Access Compliance Report

Public Rights-of-Way

(Curb Ramps)

Intersection ID: 44475	Main Street: VALCOURT_RD	Cross Street: WESTHOPE_ST	Location: SE
ADA ID: 9D3A4E96771D	Ramp Type: BlendTrans1	Initial Pass/Fail: Fail	Overall Compliance: No
		Severity Score: 10

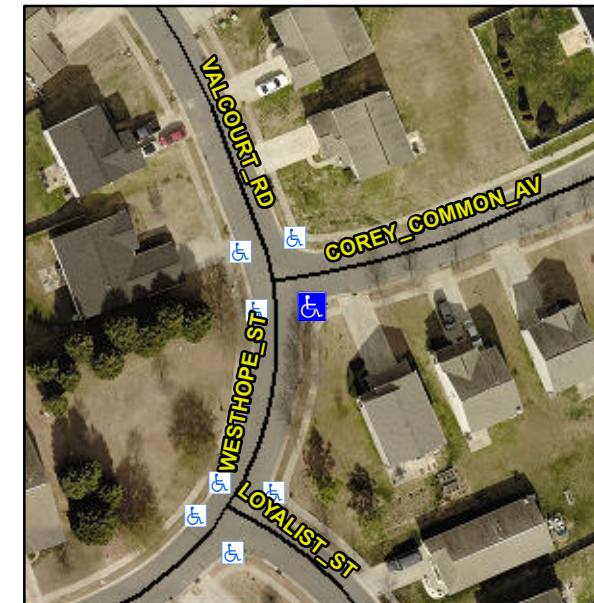
LNDG GAP 1.0

Not Found, R304.5.1, R304.5.3

Compliance	Description	Data	Compliance	Description	Data
N/A	Ramp Length (in)	45.5	Yes	BlendTrans Slope (%)	4.1
No	Ramp Width (in)	47.0	No	BlendTrans XSlope (%)	3.0
N/A	Flare Type LT	N/A	N/A	Flare Type RT	N/A
N/A	Flare Slope LT (%)	N/A	N/A	Flare Slope RT (%)	N/A
N/A	Flare Traversable LT?	N/A	N/A	Flare Traversable RT?	N/A
N/A	Landing Length (in)	N/A	N/A	DWS Provided?	N/A
N/A	Landing Width (in)	N/A	N/A	DWS Contrast?	N/A
N/A	Landing Slope (%)	N/A	N/A	DWS Length (in)	N/A
N/A	Landing X Slope (%)	N/A	N/A	DWS Full Width?	N/A
N/A	Landing Curb? (Y/N)	N/A	N/A	DWS Offset (in)	N/A
N/A	Shared Landing?	N/A			
N/A	Gutter Ponding?	N/A	N/A	Gutter Slope (%)	N/A
N/A	Gutter Lip Ht (in)	N/A	N/A	Gutter X Slope (%)	N/A
N/A	Painted X Walk1?	No	N/A	Painted X Walk2?	No
	X Walk 1 Direction	To N		X Walk 2 Direction	To W
	X Walk 1 Width (in)	N/A		X Walk 2 Width (in)	N/A
	X Walk 1 Slope (%)	1.7		X Walk 2 Slope (%)	3.8
	X Walk 1 X Slope (%)	2.6		X Walk 2 X Slope (%)	1.5

N/A	Ramp inside XWalk1?	N/A	N/A	Ramp inside XWalk2?	N/A
	Road Slope (%)	4.5		Clear Space?	N/A
	Road X Slope (%)	0.6	N/A	Clear Space to XWalk (in)	N/A
N/A	Any Obstructions?	N/A	N/A	Storm Grate/Utility Hazard?	N/A
	Obstruction Type			Storm Grate/Utility Type	
		N/A			N/A
			Yes	Surface Condition? (G/P)	Good
			No	Curb Slope (%)	9.7

Remove & Replace Curb Ramp With Two New Directional Ramps or Equivalent.
